SUBJECT: COMMENTS ON NUCLEAR ENERGY INSTITUTE 96-07, APPENDIX C:  
GUIDELINE FOR IMPLEMENTATION OF CHANGE CONTROL PROCESSES  
FOR NEW NUCLEAR POWER PLANTS LICENSED UNDER TITLE 10 OF THE  
CODE OF FEDERAL REGULATIONS, PART 52, REVISION 0C

**U.S. Nuclear Regulatory Commission**  
**Comments on NEI 96-07, Appendix C, Revision 0C**  
**Dated October 30, 2011**

**Figure 1 10 CFR Part 52 Change Process**

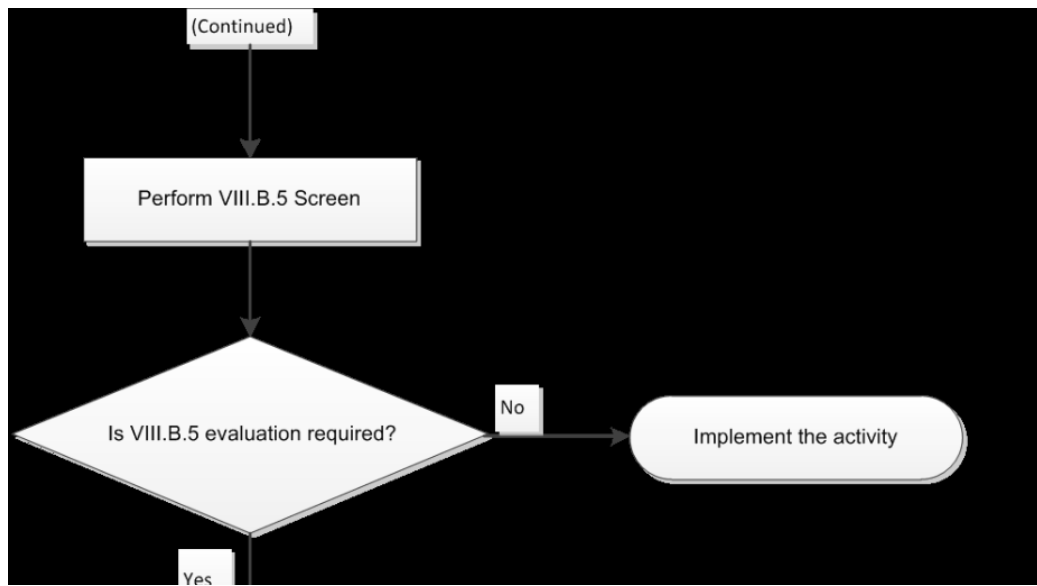
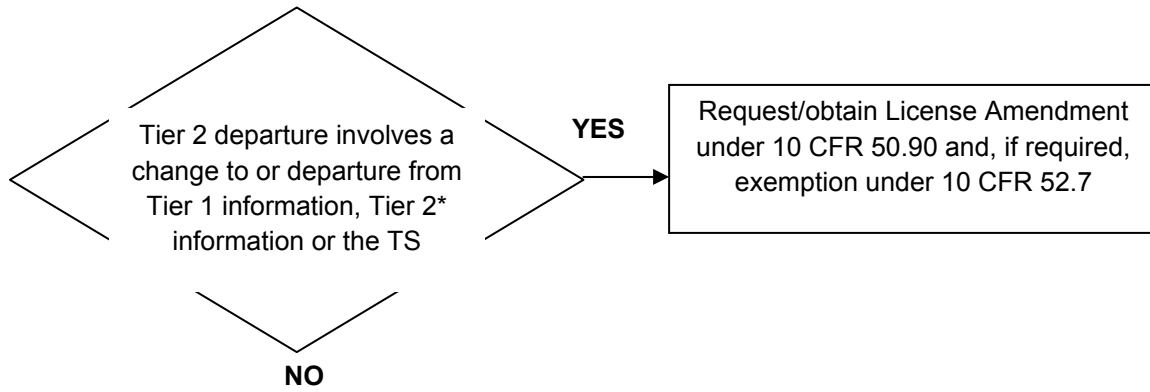
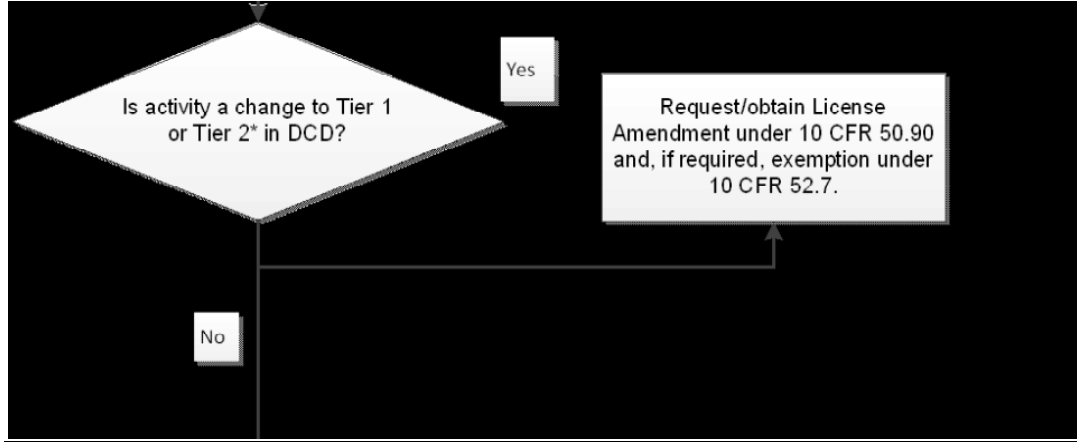
Add logic decision bi-stable diamond for evaluation of Tier 2 departure impact on Tier 1 and/or Tier 2\* information. A Tier 2 departure that involves a change to or departure from Tier 1 information, Tier 2\* information or the Technical Specifications requires a license amendment and the Tier 1 departure also requires an exemption from the design certification rule. (Section VIII.A.4, Section VIII.B.5.a, and Section VIII.B.6)

Is the activity related to site-specific FSAR information not within the scope of the ~~referenced~~ **plant-specific** DCD?

Following issuance of the COL, the FSAR contains the plant-specific design certification documentation. This plant-specific DCD information was derived from the referenced DCD. It is important to recognize the unique role the plant specific DCD plays in the safety analysis report and the change control regulations for the plant specific DCD information.
